Summary of Items Discussed in 5/2022 APSEC Discussion Forum on 25 November 2022

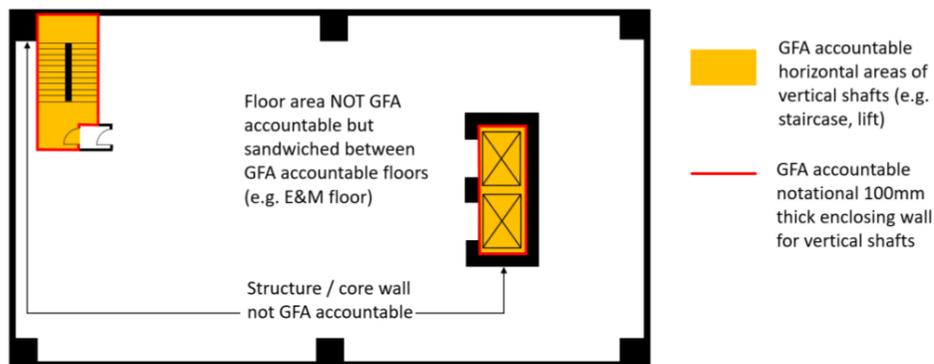
<p>5. <u>Lift Shaft and Staircase GFA passing through Floors with Non-accountable GFA</u></p> <p>It is stated in item 3 of Group I in JPN No. 4 that “<i>horizontal areas of staircases, lift shafts and vertical ducts solely serving floors accepted as not being GFA accountable</i>” are generally exempted from GFA calculation by all the three departments regardless of any GFA exemption provision under the respective lease.</p> <p>It is our understanding that the horizontal area of staircases, lift shafts and vertical ducts should normally be measured for GFA together with the floor through which they pass (e.g. E&M floors sandwiched between GFA accountable floors). We would like to seek BD’s clarification that, in the said circumstances, GFA is only measured for the horizontal areas of the staircases and the lift shaft themselves but not the enclosing walls.</p> <p>Should BD consider that enclosing walls need to be GFA accountable, we would like BD to clarify whether a notational thickness of 100 mm can be adopted, based on the logic that the 100 mm thickness of plant room wall can be disregard from GFA calculation in accordance with paragraph 12 of PNAP APP-2.</p>	<p>For the scenario illustrated by HKIA, BD clarified that apart from the horizontal areas of staircases, lift shafts and vertical ducts, the entire thickness of their enclosing walls should be fully accounted for the purpose of GFA calculation.</p> <p>BD supplemented that paragraph 12 of PNAP APP-2 referred to the disregarding of GFA of the enclosing walls for plant rooms and other features that were to be disregarded from GFA calculation, was irrelevant to the said scenario.</p>

Section

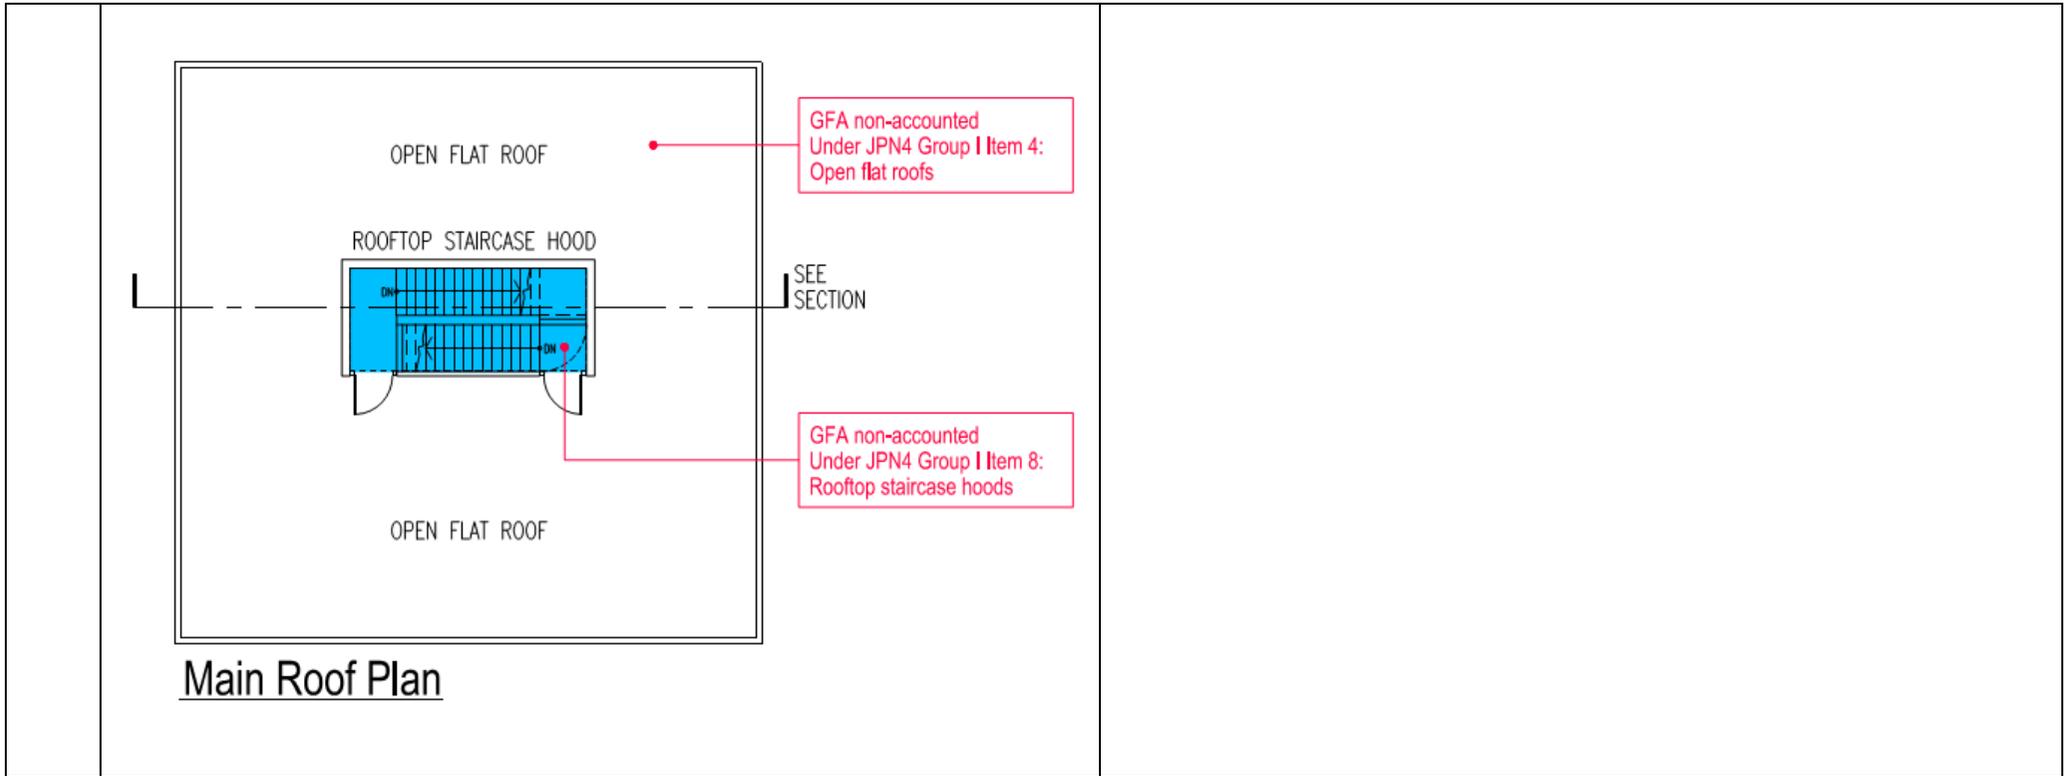
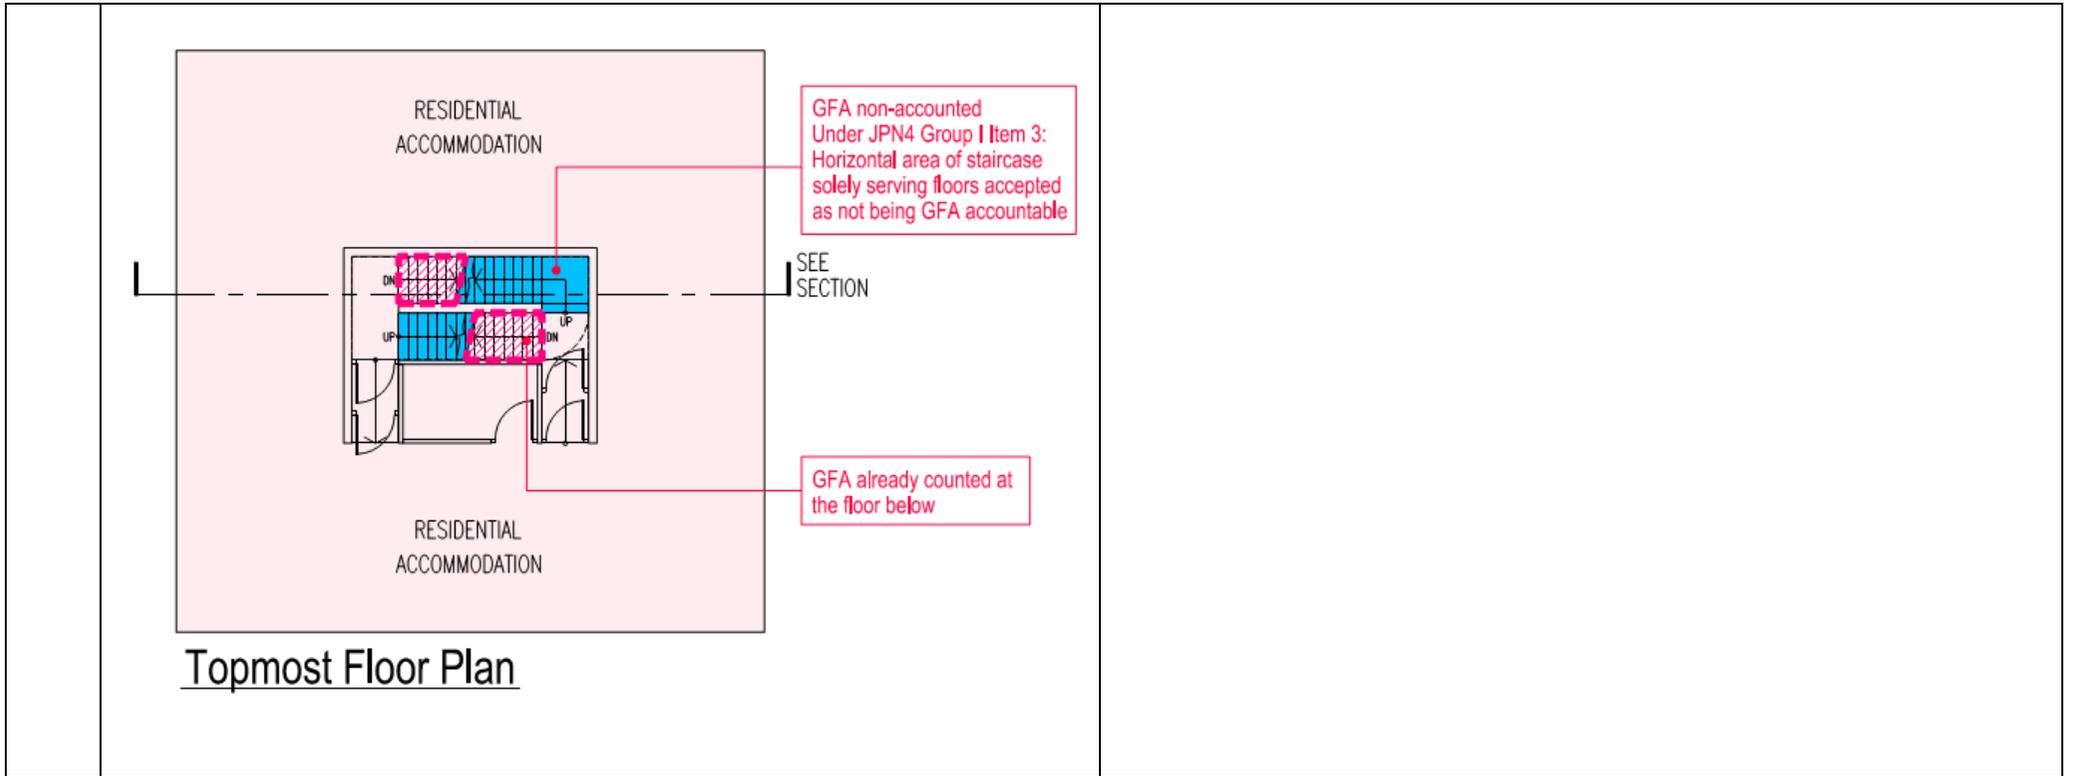
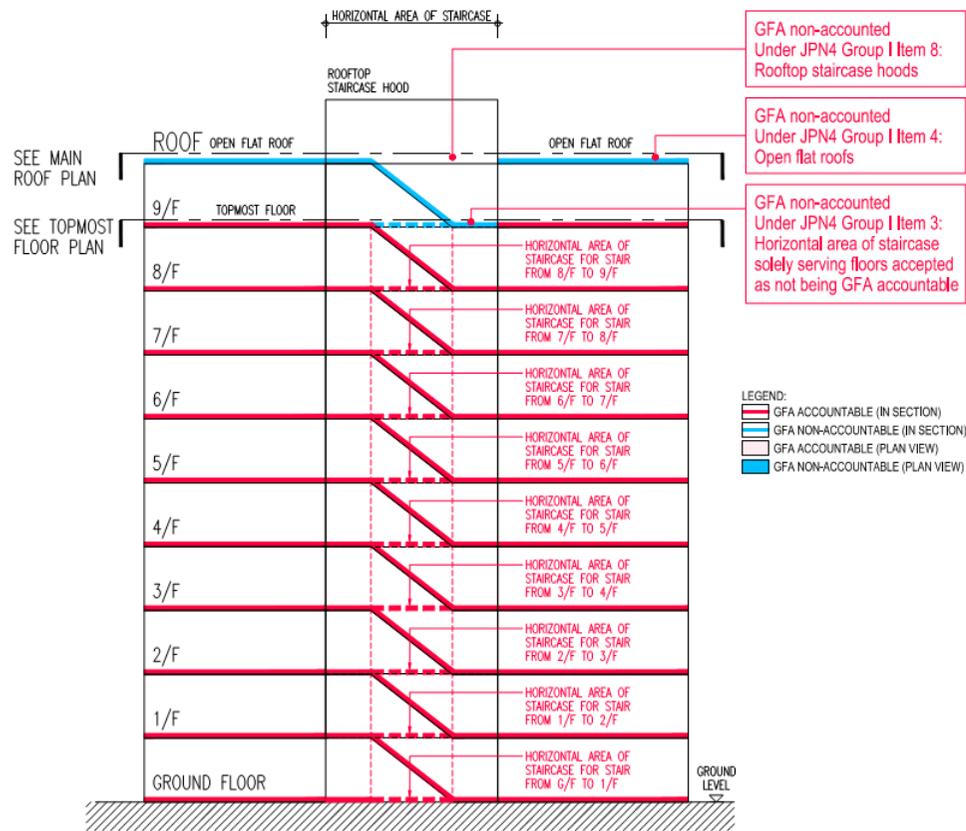
Items raised by AAP		
8.	<p><u>GFA Measurement for Horizontal Area of Staircases</u></p> <p>In accordance with JPN No. 4, the following items are generally exempted</p>	<p>BD advised that the horizontal area of staircase to be exempted from</p>

<p>from GFA calculation by all the three departments regardless of any GFA exemption provision under the respective lease:</p> <ol style="list-style-type: none"> 1. Group I Item 4, open flat roofs 2. Group I Item 8, rooftop staircase hoods of residential developments (size being not excessive and that no other building facilities, features and structures at roof are accountable for GFA) 3. Group I Item 3, horizontal areas of staircases solely serving floors accepted as not being GFA accountable <p>Therefore the calculation of GFA for the staircases to reflect the above can be illustrated as follows:</p>	<p>GFA calculation should refer to its horizontal area on that particular floor which was exempted from GFA calculation. Item 2 of ADF 4/2012 held on 3 August 2012 and item 7 of ADF 4/2014 held on 8 August 2014 also clarified that area of the staircase would be measured at each floor level for the purpose of GFA calculation. In the illustrated scenario, the topmost floor was GFA accountable and therefore the horizontal area of the staircase connecting to the roof at the topmost floor level should be included in GFA calculation. This had long been the practice adopted by BD on measurement of GFA for staircase.</p> <p>BD also advised that the space underneath the staircase connecting to the roof as highlighted in blue dotted line in the Section illustrated, should be GFA accountable as per item 8 of ADF 1/2021 held on 22 January 2021 regarding GFA calculation of space below open staircase to roof.</p>

Would BD please advise if our understanding is correct?

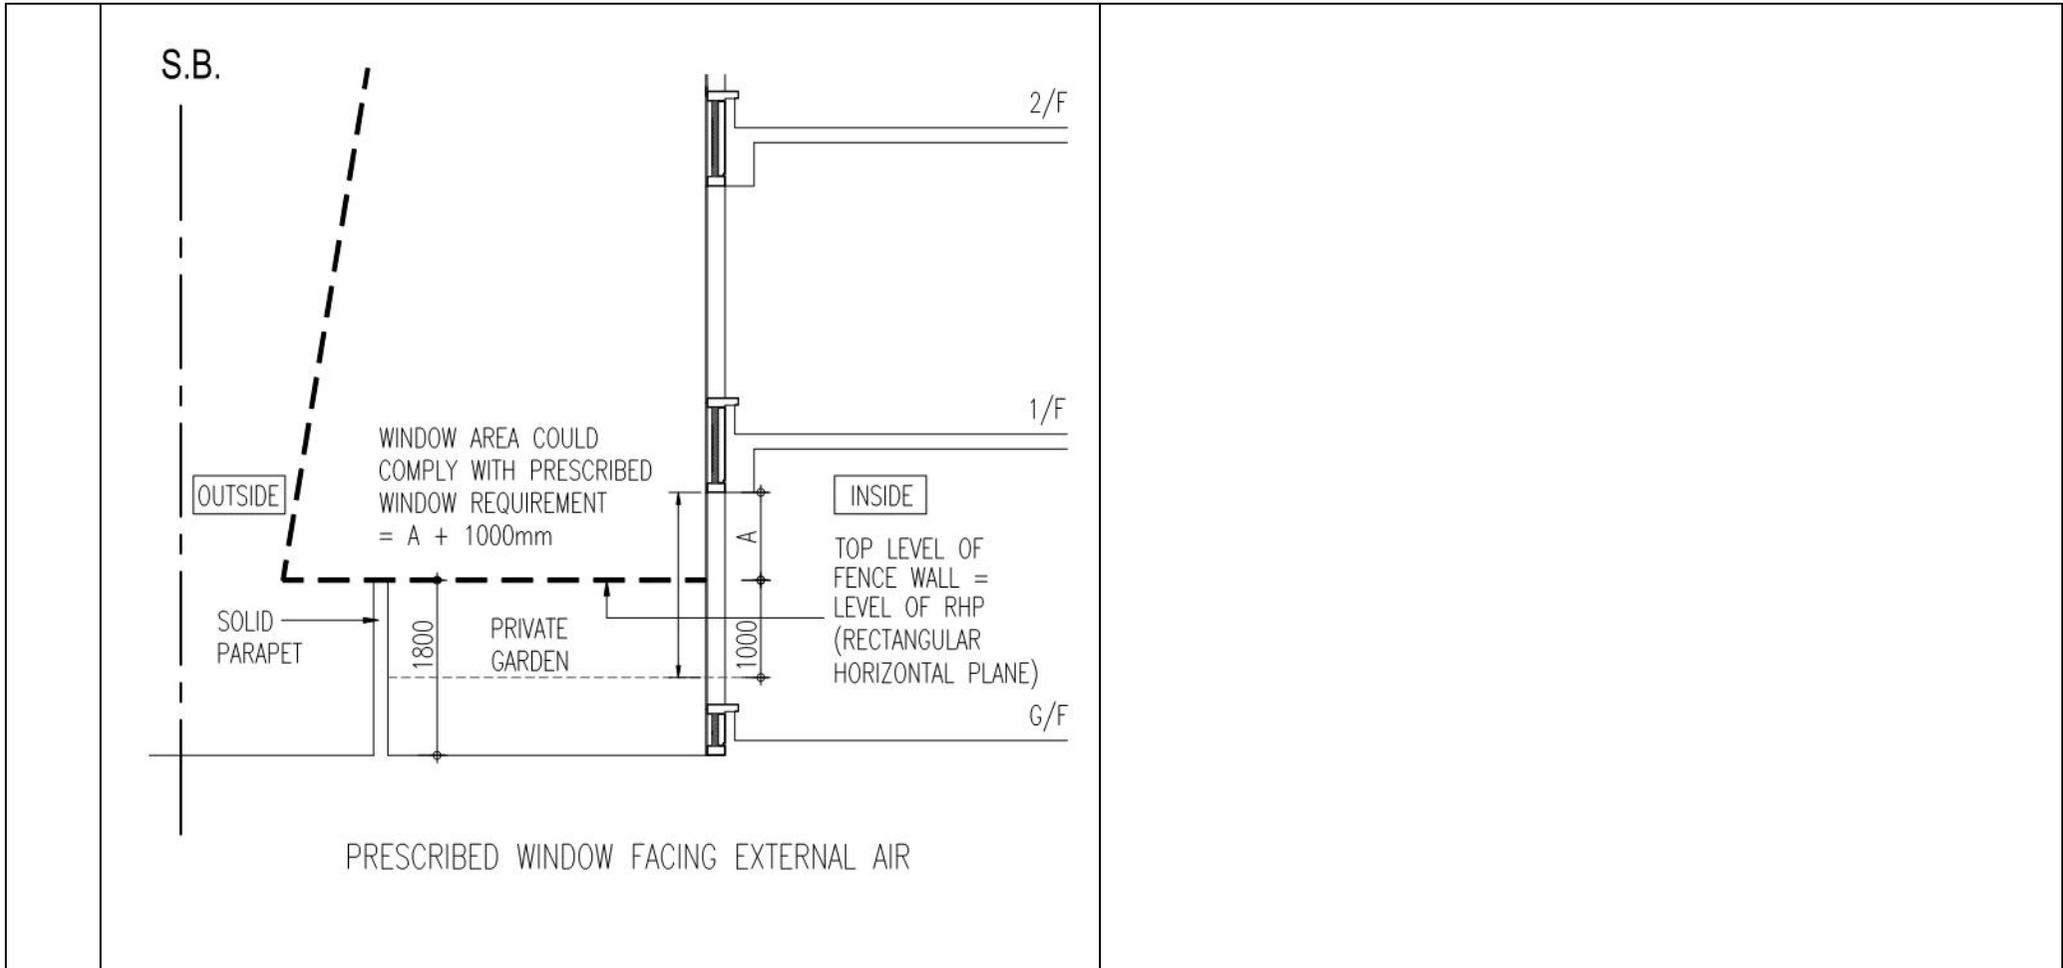
<p>b) For prescribed window facing fence wall, the measurement of the prescribed window should be from the top of fence wall instead of at 1 m A.F.F.L.</p> <p>Based on the above principles, we would like to BD to clarify that in case the window sill (i.e. the rectangular horizontal plane) is taken at the top level of fence wall (say 1.8m A.F.F.L.), whether the superficial area of the glazing and window opening for 1 m below that window sill level can be counted towards the aggregate glazing area and aggregate openable window area as well.</p>	<p>applicable to the scenario depicted in the sketch.</p>
--	---

Item 16 of ADF 2/2020 held on 29 May 2020 related to window facing into a balcony, and Item 4 of ADF 2/2015 held on 20 March 2015 related to window facing a street of not less than 4.5 m wide, were not

Figure 10.1 - Typical composite beams

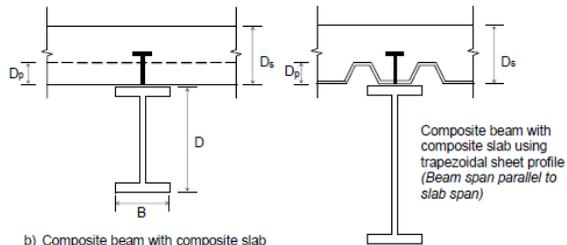
14.	<p><u>Application of Steel Reinforced Concrete (SRC) in Composite Beam Design</u></p> <p>Figure 10.1 of Code of Practice for the Structural Use of Steel 2011 (2021 Edition) (Steel Code) illustrates the typical section of composite beam arrangement of concrete slab and steel I-beam as follows:</p>	<p>BD advised that Figure 10.1 of the Steel Code only illustrated the sections of typical composite beams, and BS EN 1994-1-1:2004 stipulated under Section A2.3 of Annex A of the Steel Code provided the requirements of acceptable composite beam design. For unconventional composite beam design not provided in the said standard, the proposed design would be considered on case-by-case</p>

We would like to enquire if SRC can be applied to composite beam design given this form has already been commonly applied to composite columns.

basis and might be submitted to the Structural Engineering Committee for deliberation if necessary.
